**CITY OF LA VISTA**  
**MAYOR AND CITY COUNCIL REPORT**  
**JANUARY 21, 2020 AGENDA**

<b>Subject:</b>	<b>Type:</b>	<b>Submitted By:</b>
CONDITIONAL USE PERMIT – CASEY'S RETAIL COMPANY – LOT 3 HARRISON HILLS (118 <sup>TH</sup> & HARRISON ST)	◆ RESOLUTION ORDINANCE RECEIVE/FILE	CALE BRODERSEN ASSISTANT PLANNER

PCUP 19-0004

RE: Conditional Use Permit – Initial Review Response Letter  
Proposed Casey's – 118<sup>th</sup> & Harrison  
Lot 3, Harrison Hills  
Convenience Store & Gas Station  
Schemmer Project No. 06754.064

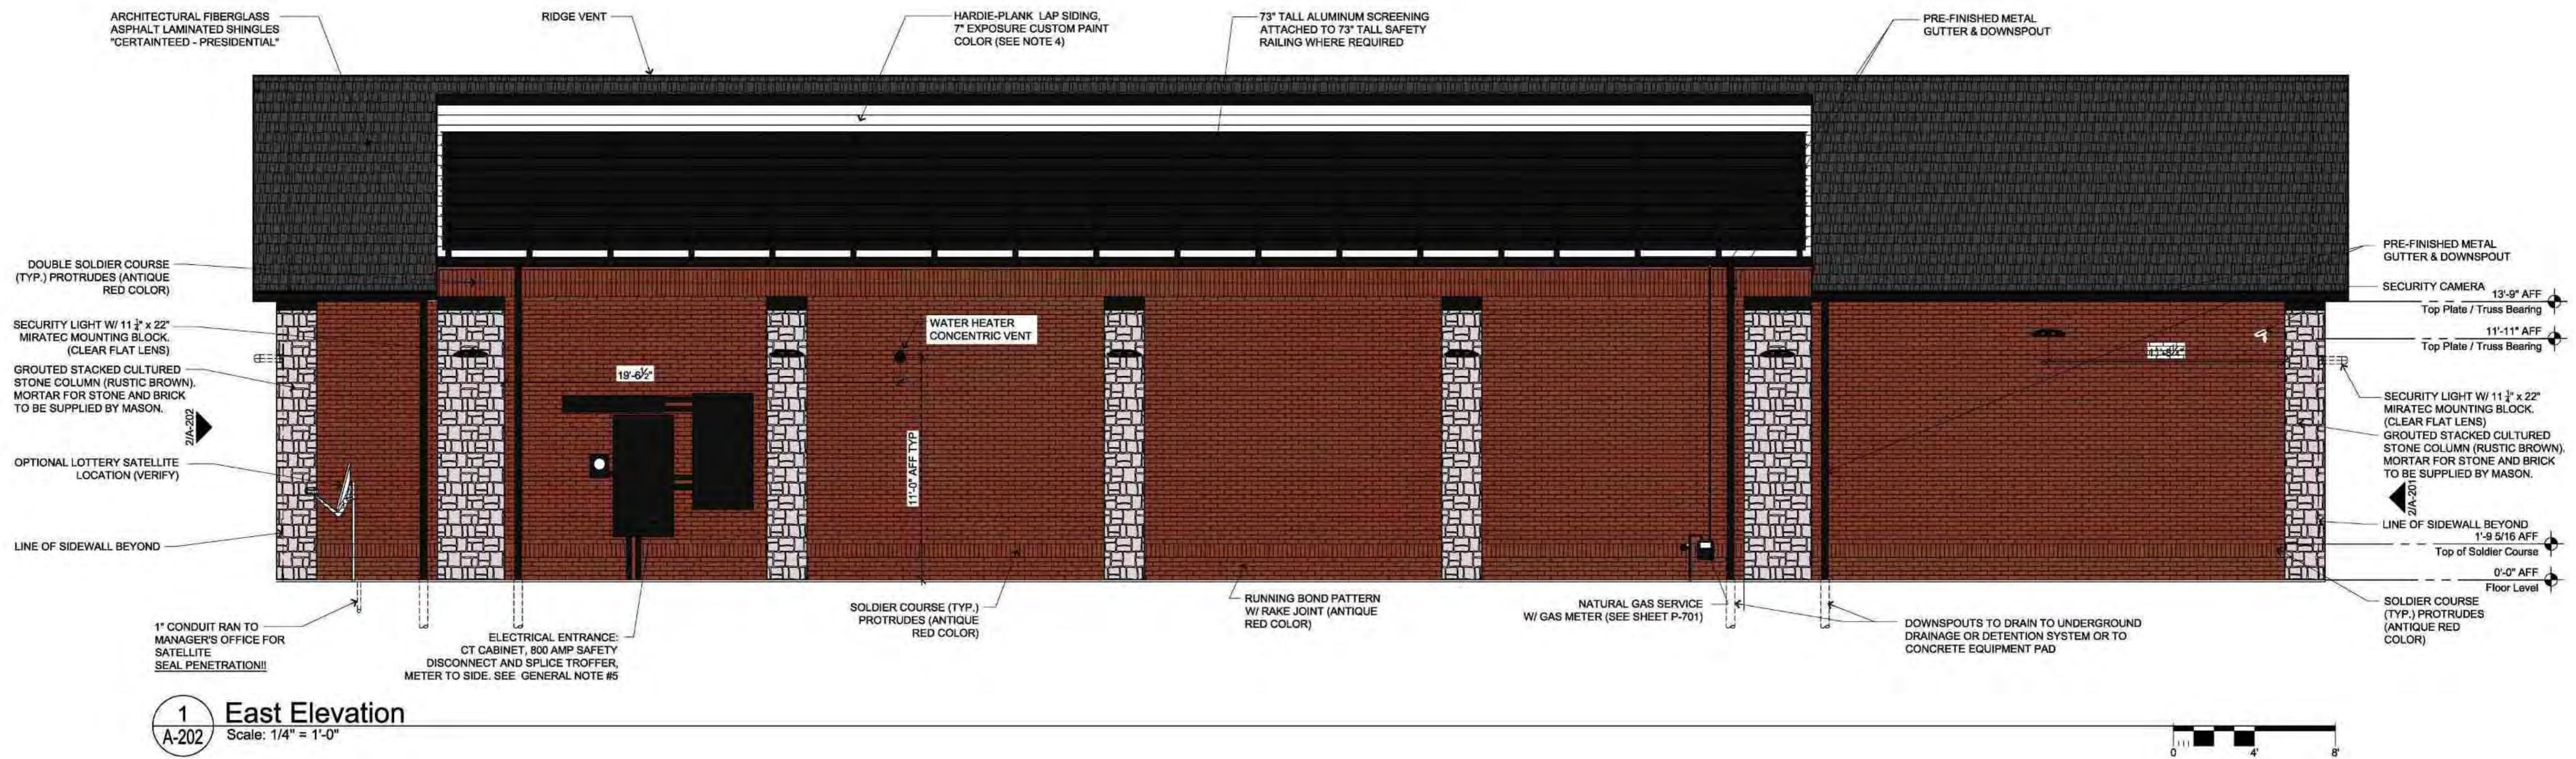
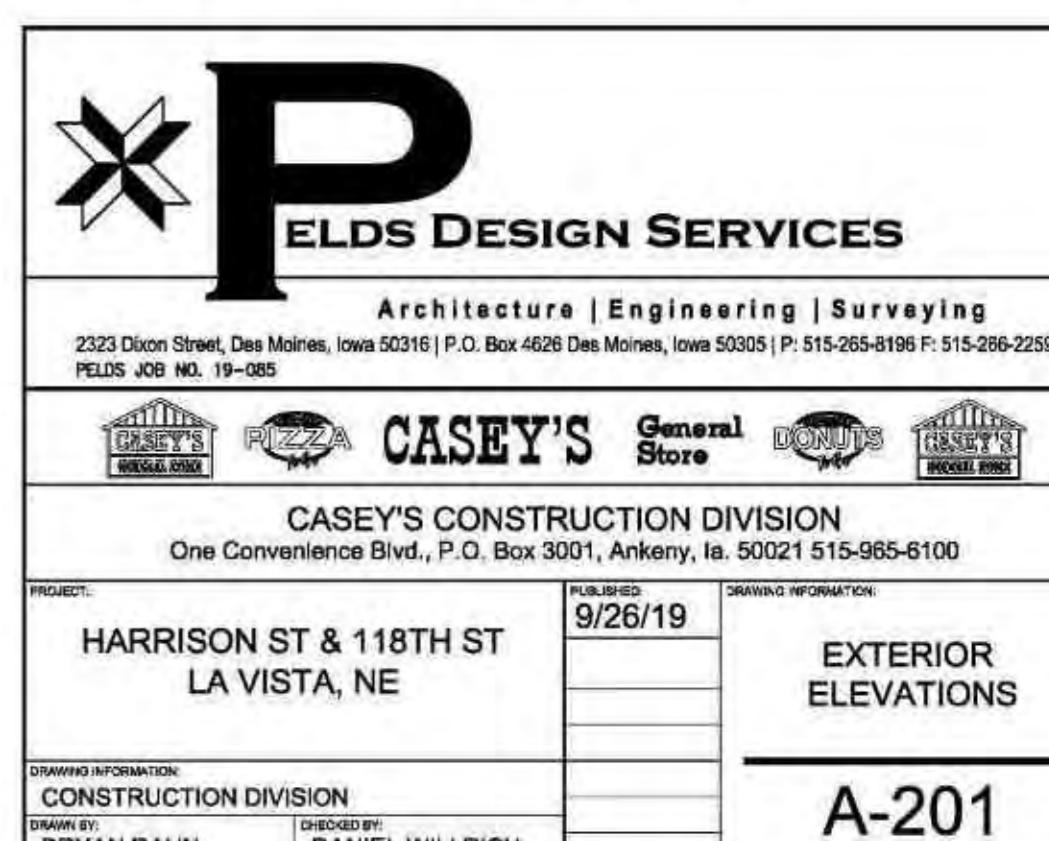
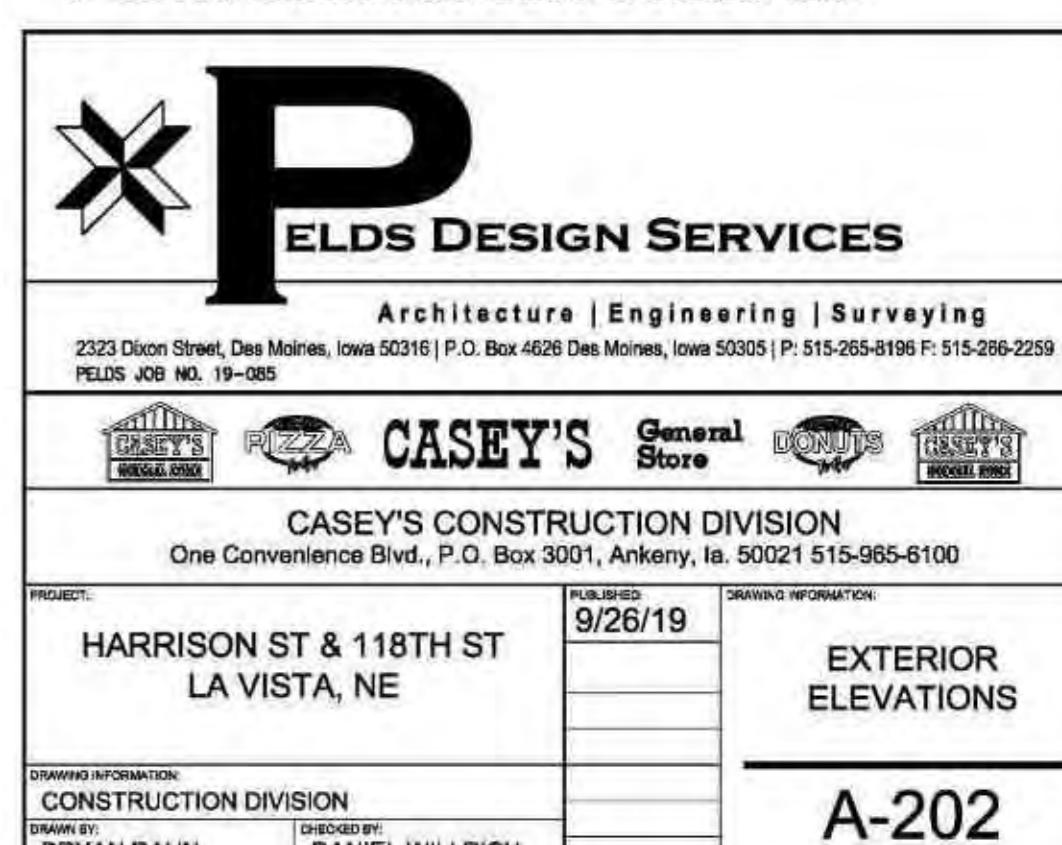
- Scale of building. Gable ends are 4x pedestrian scale. Current design provides no detail in upper portion of wall. Stone at lighting only breaks up lower portion of wall. Suggest additional color/detail of upper gable area. Pilasters terminate into more brick with minimal detail.

- Four-sided building: See note above regarding the side elevations. The south side does appear as a back. An option to detail the mechanical area as more of a porch with horizontal stone between the stone piers creating a porch look would help break up that elevation. Suggest moving the lighting to the pilasters under the center mechanical area only as on the sides to minimize attention to the utilities.

- Scale of building. Gable ends are 4x pedestrian scale. Current design provides no detail in upper portion of wall. Stone at lighting only breaks up lower portion of wall. Suggest additional color/detail of upper gable area. Pilasters terminate into more brick with minimal detail. **Corrected per submittal Jan. 7<sup>th</sup>to an acceptable level.**

- Four-sided building: See note above regarding the side elevations. The south side does appear as a back. An option to detail the mechanical area as more of a porch with horizontal stone between the stone piers creating a porch look would help break up that elevation. Suggest moving the lighting to the pilasters under the center mechanical area only as on the sides to minimize attention to the utilities. **Corrected per submittal Jan. 7<sup>th</sup>to an acceptable level.**
